Proj. No.: SUR2201

Subject: Addendum No. 2
Surf City WWTF Digester/Sludge Holding Tank
Surf City, NC
Owner: Town of Surf City

ADDENDUM NO. 2

C SECTION AT PIPE SUPPORT FRAME
S13 SCALE: 3/4" = 1'-0"

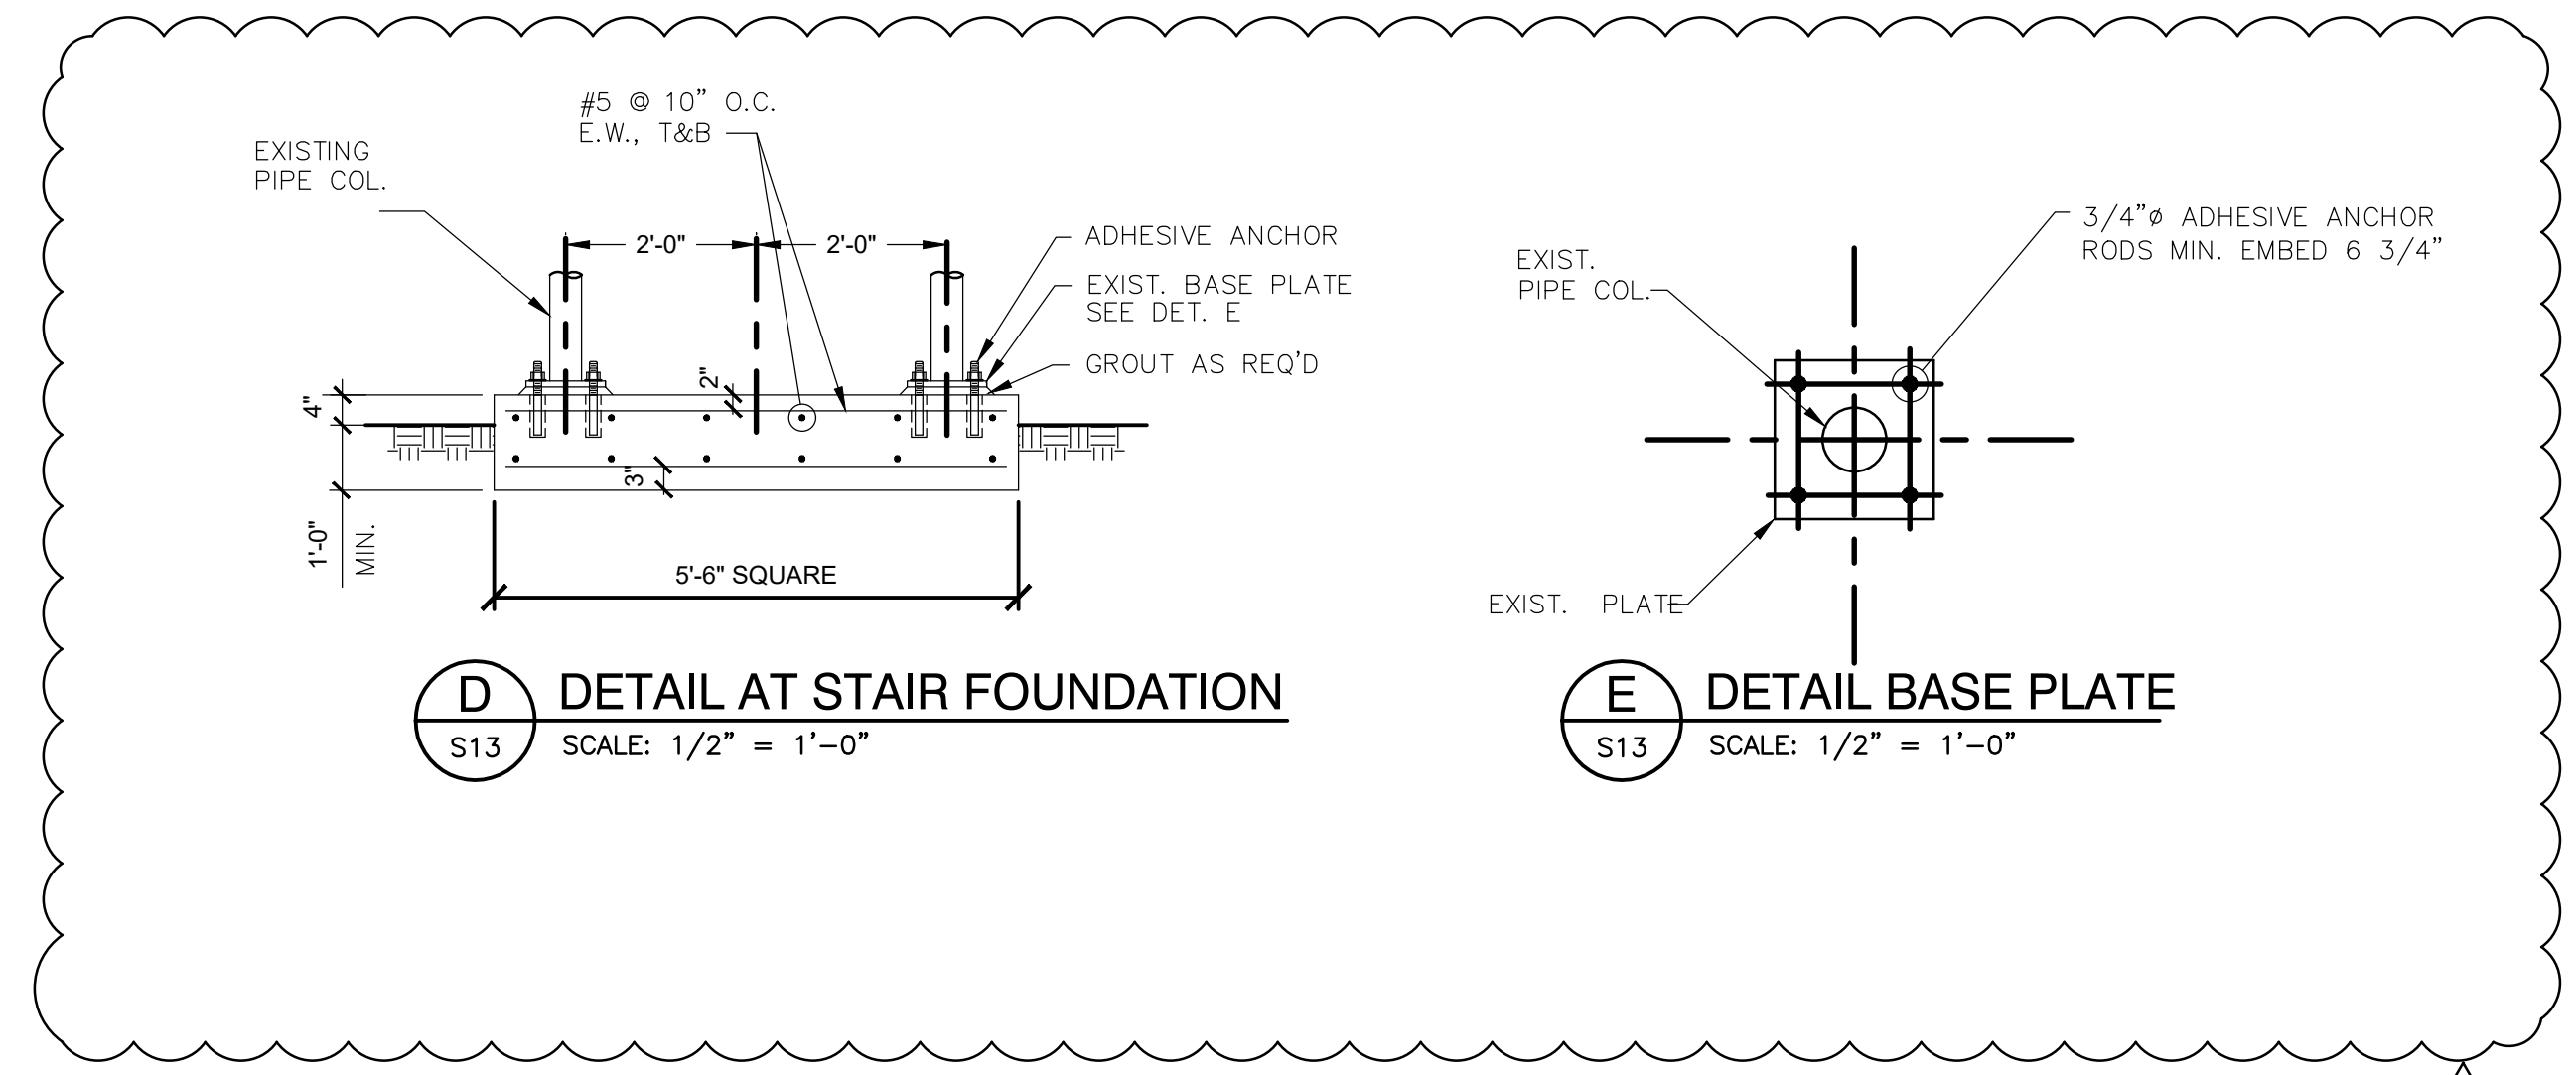
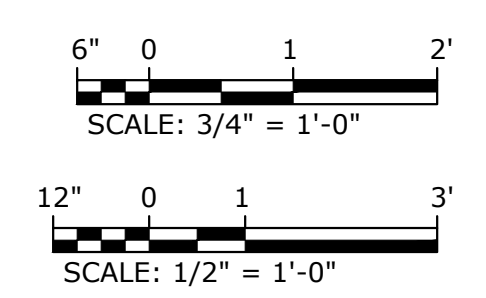
Item 2.22: Please provide a detail for the new stair column support foundations shown on A/S13.

Refer to Sheet S-13 – Stair Sections and replace with the attached.
